Fresenius Medical Care North America Service Bulletin

Equipment: 2008T Hemodialysis Machines
 Bulletin: 19-FRT-001 Rev B
 Subject: 2008T Machines With New Style Hydraulics

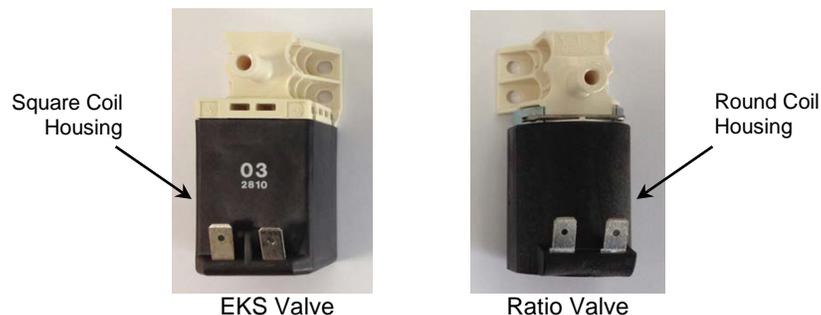
- The acid and bicarbonate inlet lines have been extended to 8 feet in length to ease in the use of a central concentrate system. If a central concentrate system is not used, these lines can be shortened to the previous length.
- These hydraulics include extended life components inside the acid, bicarbonate and Ultrafiltration pumps. These components qualify the machine for a 2 year preventive maintenance (PM) schedule.
- The valves have been upgraded from an “EKS” valve to a “Ratio” valve. They can be identified in the figures below. These valves can be used interchangeably in the hydraulics.
